From: Scala, Mary Joy [mailto:scala@charlottesville.org]
Sent: Wednesday, April 20, 2016 9:10 AM
To: Andrew Garlock; Charlie Armstrong (CharlesA@southern-development.com); Kevin Lewis
Subject: BAR Action - William Taylor Plaza - April 19, 2016

BAR 15-08-04

Proposed new construction of a Marriot Hotel on the NW corner intersection of Cherry Avenue and Ridge Street – plaza facade design

**CITY OF CHARLOTTESVILLE
BOARD OF ARCHITECTURAL REVIEW
STAFF REPORT
April 19, 2016**

1 **SOUTHWEST ELEVATION**
SCALE: 3/32" = 1'-0"

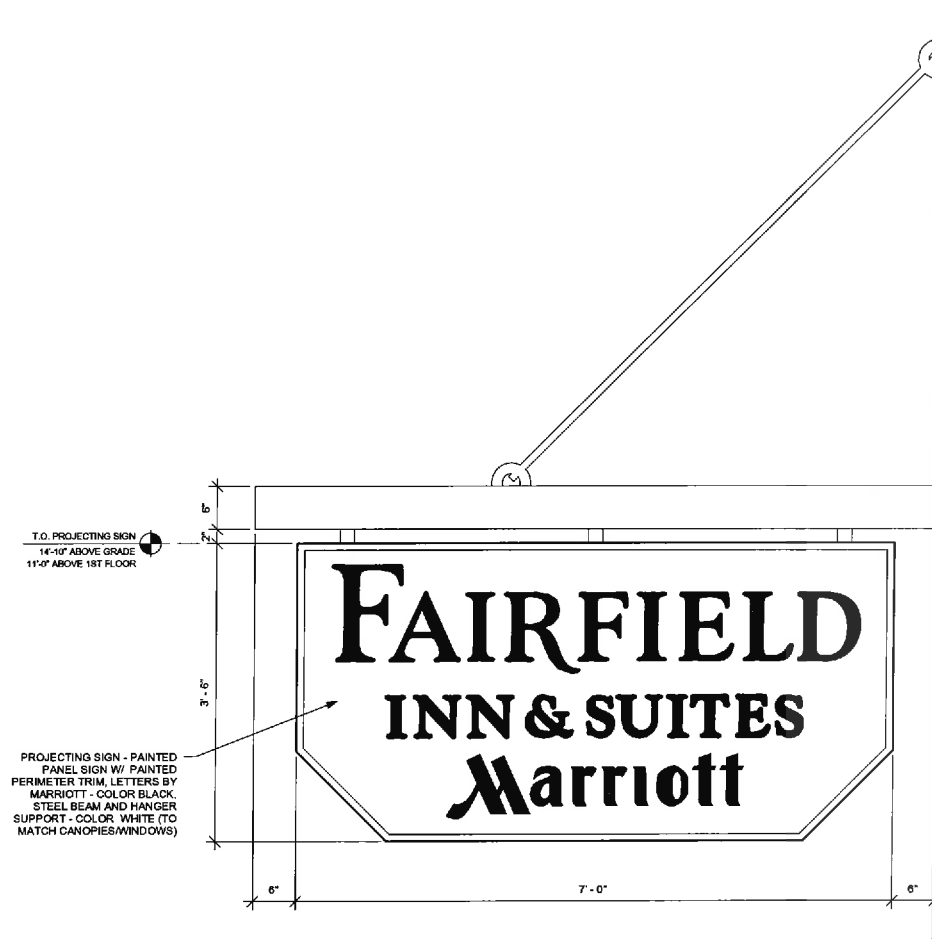
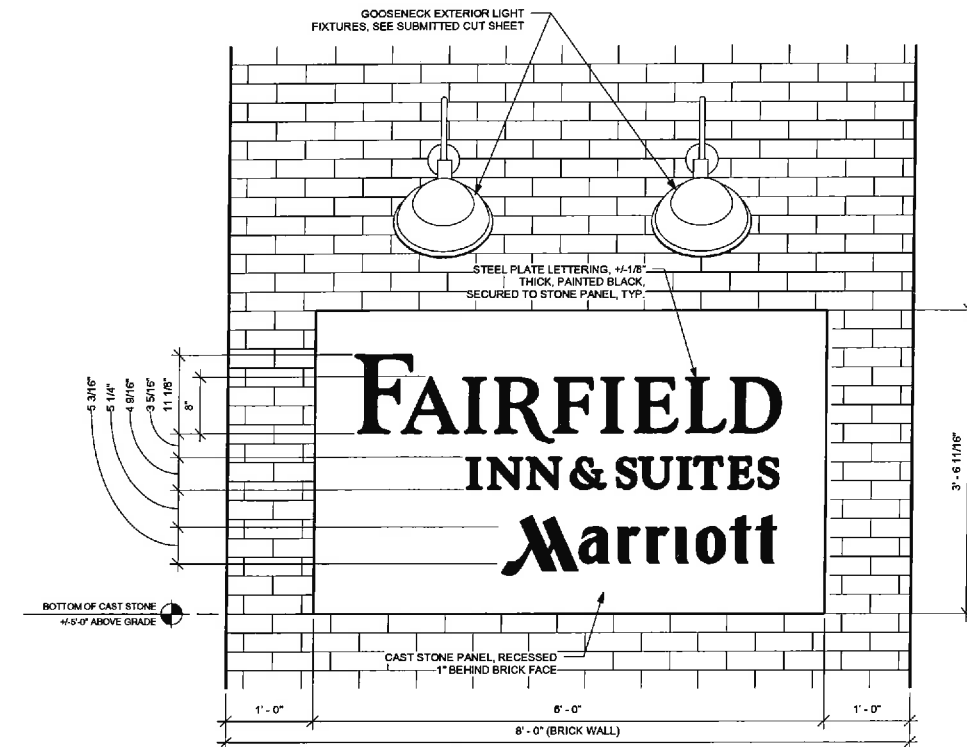
On March 15, 2016 the BAR considered the remaining items below and signed off on all except two- the corner plaza brick façade, and the signage associated with it. They said the massing is correct, but not the rest of it (details). One suggested glazing in the corner space to turn the corner. They said the signage would directly relate to any changes made in the brick.

Corner Plaza Brick Façade – Our design emphasis here was to detail and frame the brick tower facing ridge street and not erode the corner of the building with glazing/storefronts. With some minor modifications to the design, we could extend the storefront system to the corner. We hesitate to wrap the brick corner with the storefront and disturb the integrity of the Cherry Ave. brick facades. Extending the storefront across the Ridge Street façade will open it up much more and also break the brick wall plane up. We could make these design changes and resubmit for approval if the current design is not approved.

We provided (2) exterior balconies on the corner to help transition from one façade to the other. The balconies also add visual depth to the façade. Below the balconies, we’ve provided the entry into the commercial space. We decided to move the entry over away from the entry into the hotel to eliminate confusion on which entrance is for the commercial space. This also eliminates the awkward corner that we had before with the façade. All of the materials proposed in the new design are materials that have already been approved for the project.

1 CHERRY AVE SIGNAGE (CORNER)
SCALE: 1" = 1'-0"

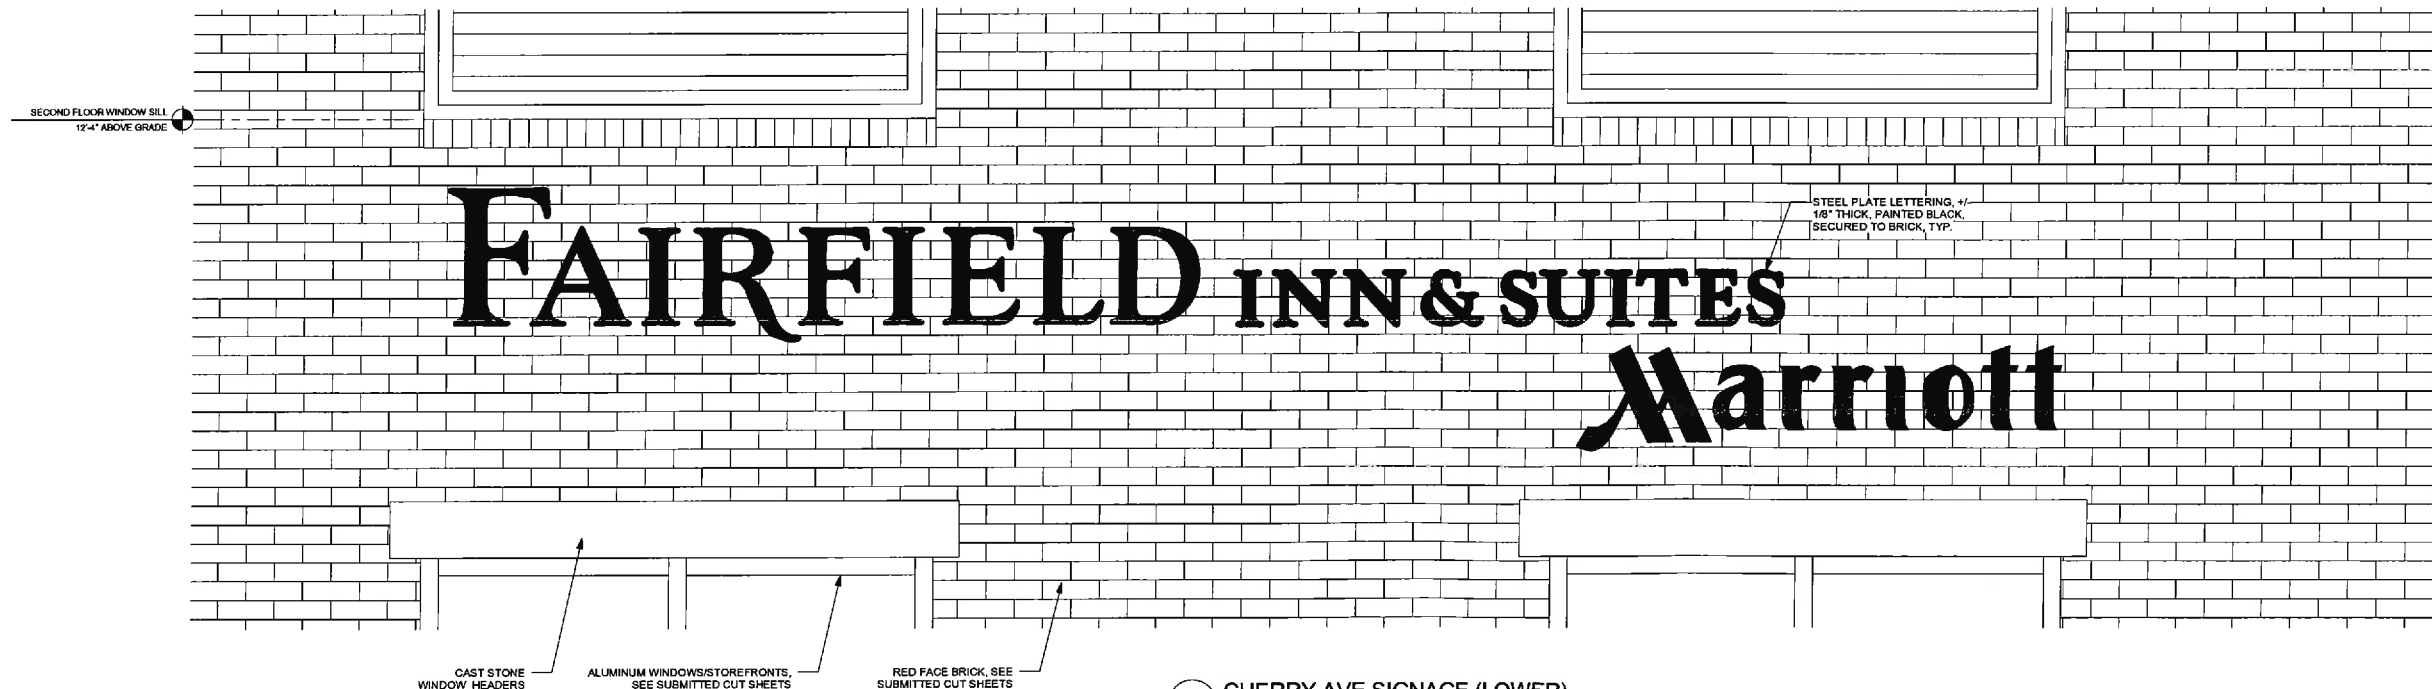
The sign ordinance allows 3'-6' for projecting sign, so that would not be permitted. You could use a monument sign in the landscaped planter- could be 24 sq feet. The aggregate would be 100 sq ft – that would include your Cherry Ave wall sign, and this sign. Your porte cochere sign is not counted because it cannot be seen from the public road.

One question about this projecting sign. The zoning ordinance only permits a projecting sign to project a max of 3'-6" out from the facade. The problem is 3'6" will not give us enough area for what we need. Is there any way we can get the proposed signage approved as it is designed? If it will be difficult, we may just remove the signage from the corner altogether. Please let me know what your thoughts are on this and I will make revisions before sending out to the BAR members.

I greatly appreciate your comments and guidance with the signage on the corner. We decided to go with a monument sign in the planter bed as shown in the drawings and renderings.
